AUBURN HILLS 7TH ADDITION

RE: S/D 98-83 -- Final Plat of Portion of Overall Preliminary of AUBURN HILLS 7TH
ADDITION

CASE NUMBER: S/D 98-83 - AUBURN HILLS 7TH ADDITION

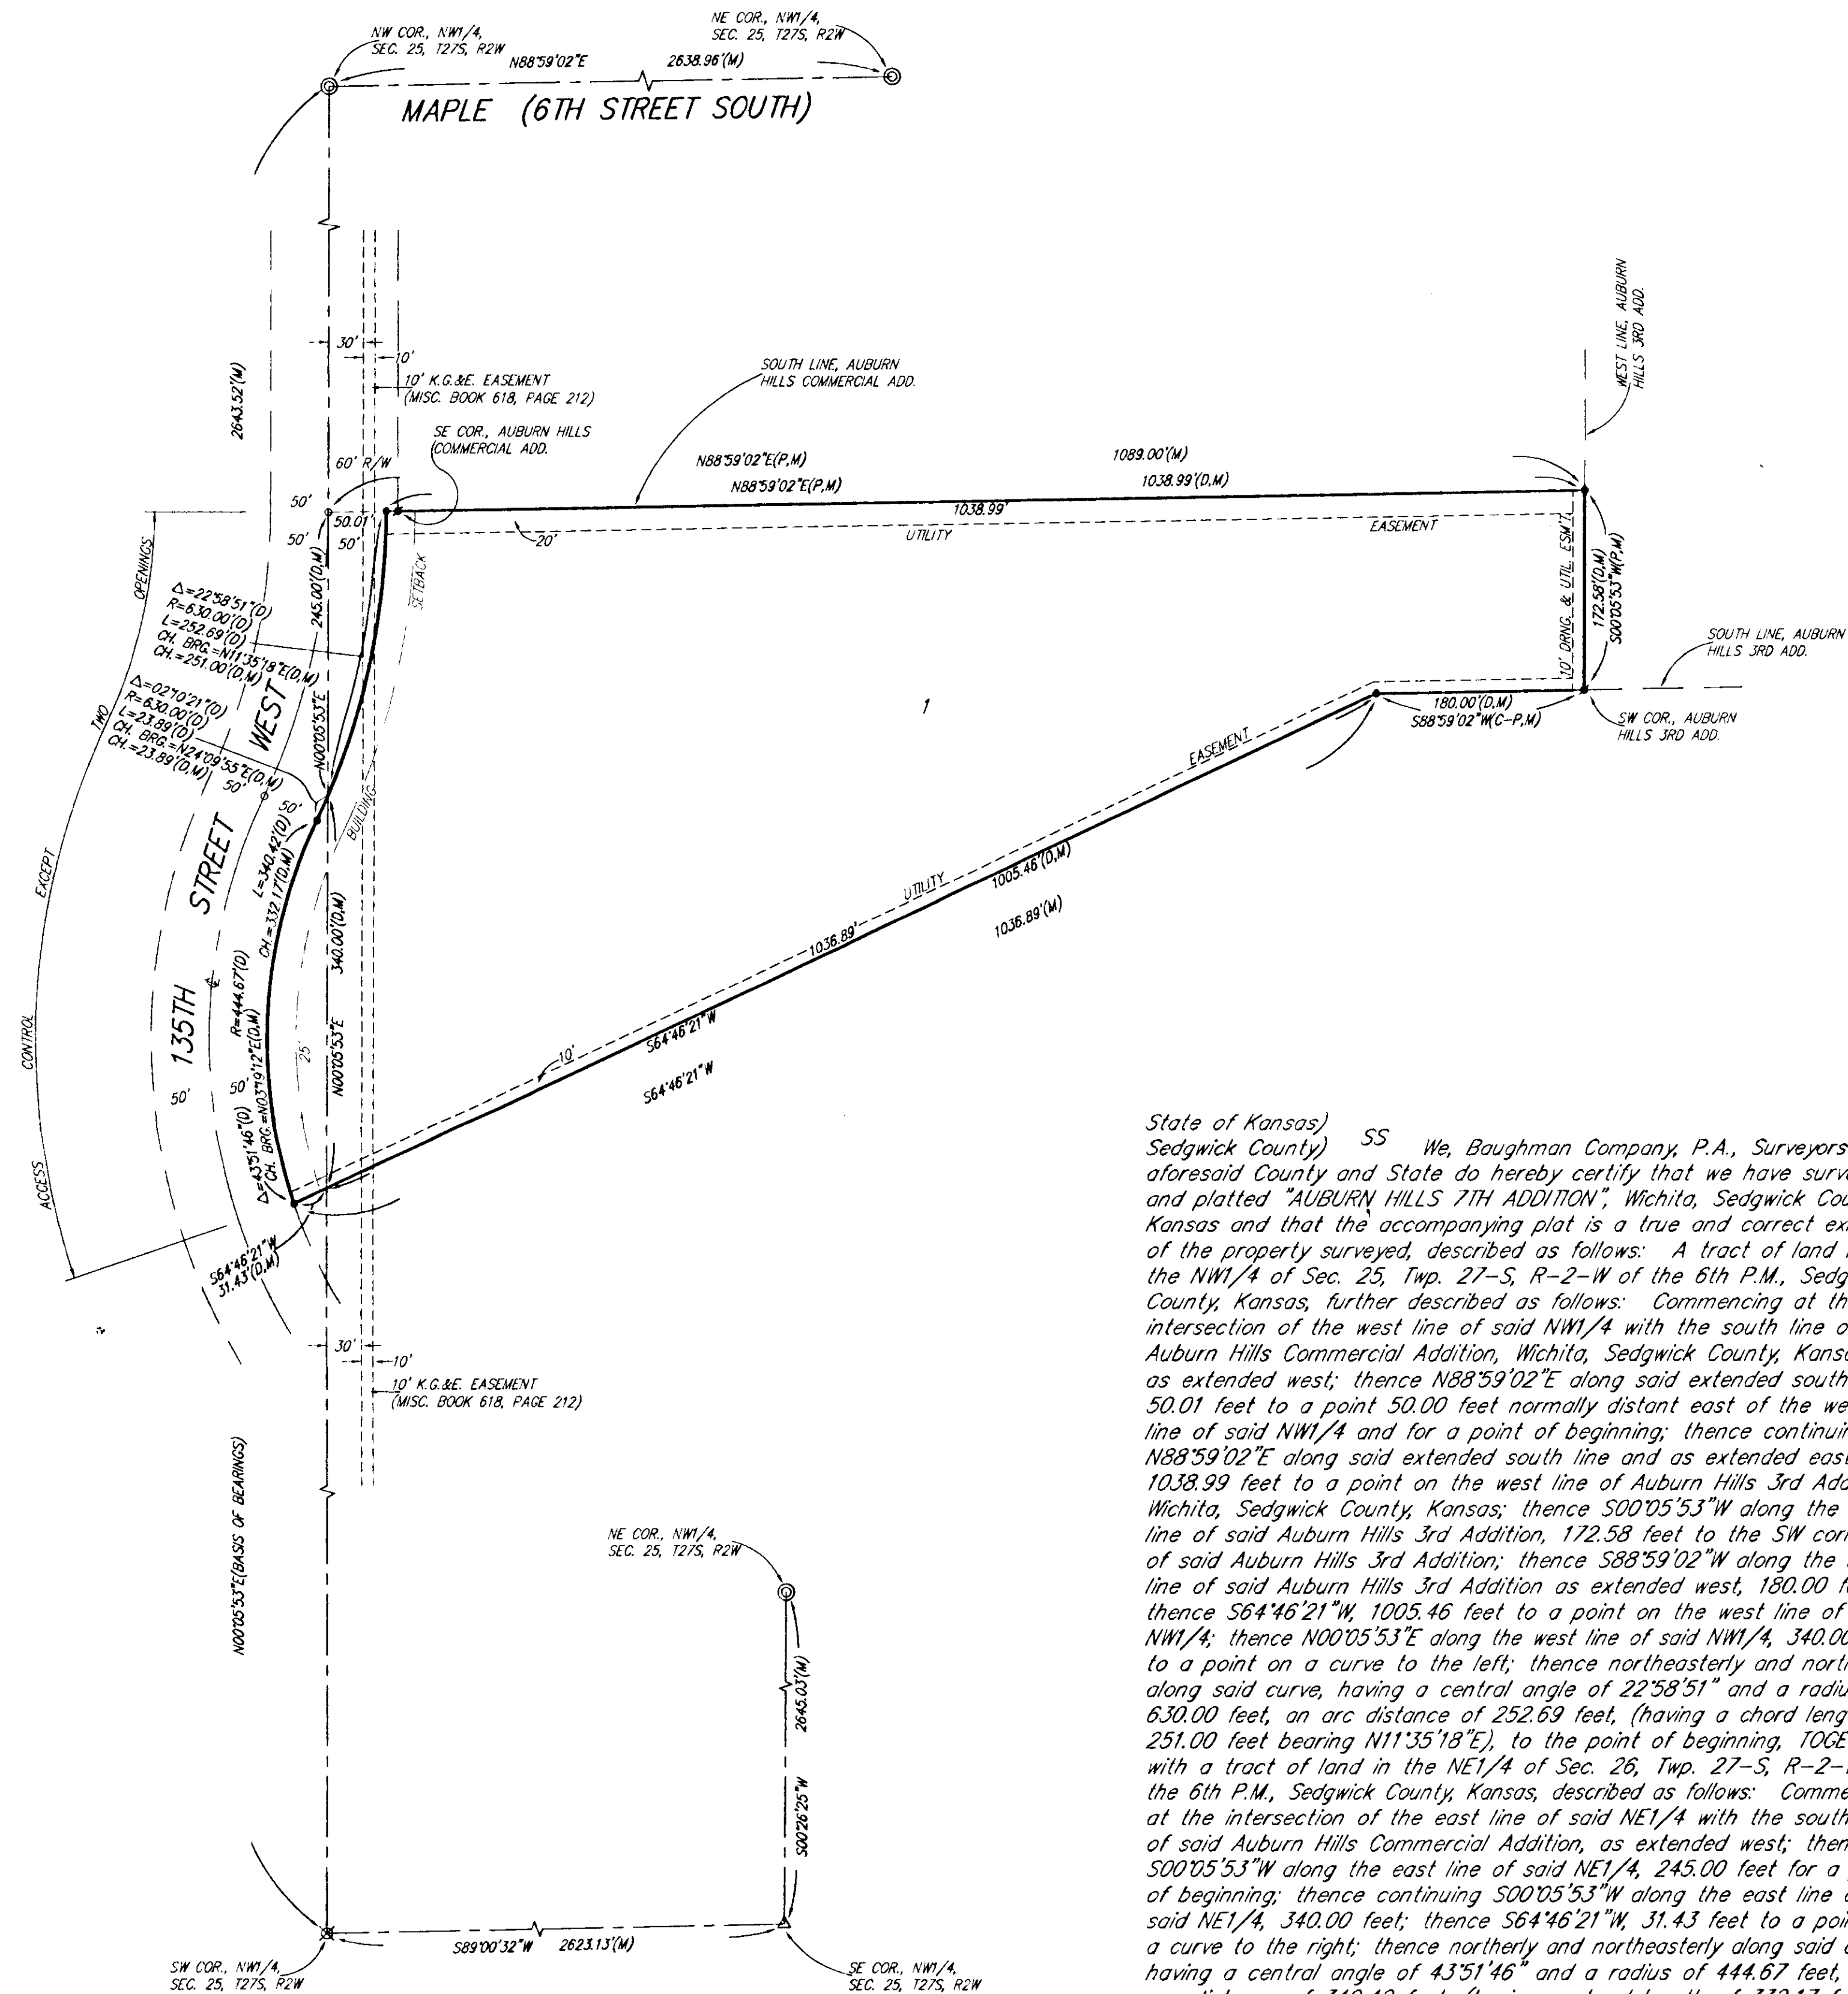
- A. City Engineering needs to comment on the need for any guarantees. *The applicant shall submit a guarantee for extension of City water. A right-of-way dedication will need to be established by separate instrument for the relocation of 135th St. West. A paving guarantee is required for 135th St. West.*

- C. City Engineering needs to comment on the status of the applicant's drainage plan. *The drainage plan is approved.*
- D. Traffic Engineering needs to comment on the two access openings denoted along 135th St. West. *The access controls are approved.*

- E. Based upon the platting binder, the site is also in the ownership of other parties. These parties need to be made signatories to the plat.
- F. The applicant is reminded that in accordance with the Protective Overlay, a landscape buffer is required along 135th Street, at least 40 feet from the lot line.

- H. A note shall be placed on the face of the plat indicating that this Addition is subject to conditions of Protective Overlay No. 38.
- I. The applicant shall install or guarantee the installation of all utilities and facilities which are applicable and described in Article 8 of the MAPC Subdivision Regulations. (Water service and fire hydrants required by Article

- P. The representatives from the utility companies should be prepared to comment on the need for any additional utility easements to be platted on this property. **Southwestern Bell has requested additional easements.**
